UNITED STATES PATENT AND TRADEMARK OFFICE

APPLICATION NO.	FILING DATE	FIRST NAMED INVENTOR	ATTORNEY DOCKET NO.	CONFIRMATION NO.
10/647,049	08/22/2003	Ernest L. Taylor	9926.003	1566

Office Action Summary

FIG. 2.

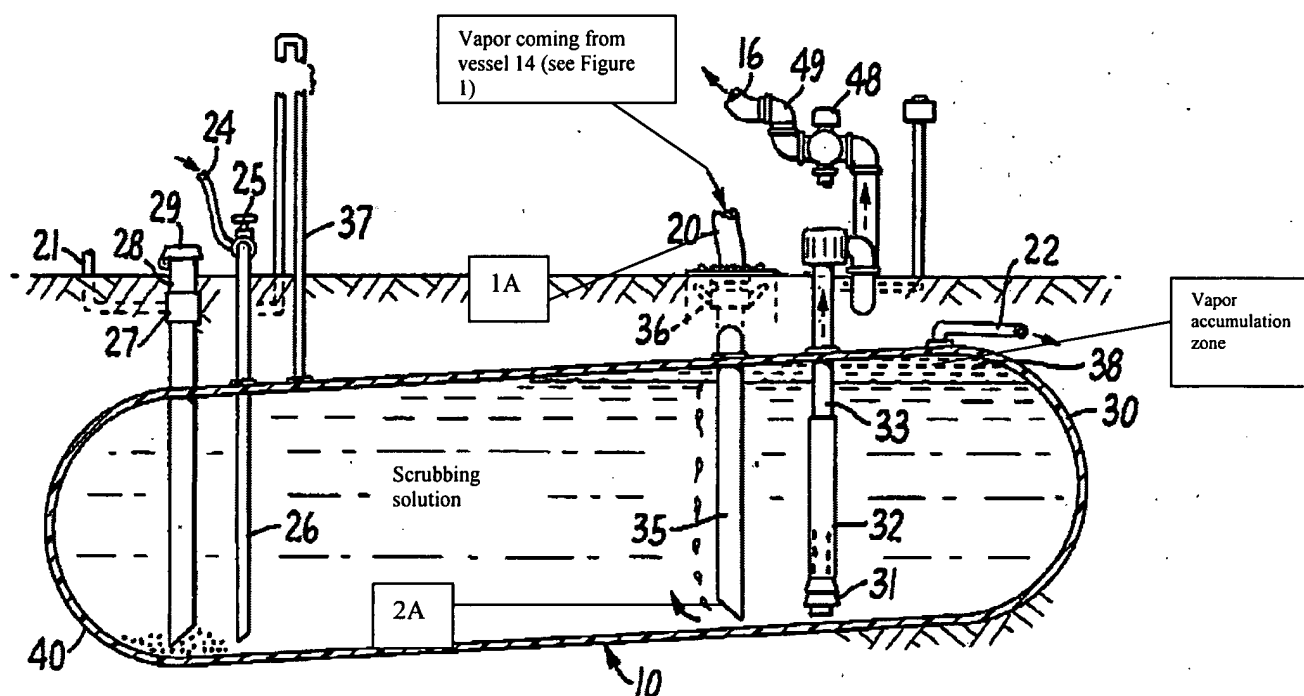
With respect to claim 1, **Vazin** teaches a vapor evacuation device for removing and scrubbing vapors from a vessel 14 comprising: a housing 10 configured to contain a scrubbing solution (water*), said housing substantially enclosing a fluid passageway 35, said fluid passageway having a first aperture 1A configured to permit the introduction of a fluid into said

fluid passageway 35, said fluid passageway 35 further comprising a second aperture 2A positioned downstream from said first aperture 1A, whereby fluid entering said passageway 35 will flow from said first aperture towards said second aperture, said second aperture configured to provide fluid communication between said housing 10 and said fluid passageway. See particularly **Figure 2**; and column 4 lines 45-47, 56-60, 62-63 of Vazin.

With respect to claim 11, **Vazin** teaches a method of evacuating and scrubbing vapors from a vessel 14 using a vapor evacuation device as described in claim 1, comprising: filling said housing 10 with said scrubbing solution, connecting said first aperture 1A to said vessel 14 whereby said vapor will flow through said fluid passageway 35 and through said second aperture 2A into said scrubbing solution. See particularly **Figure 2** of Vazin.
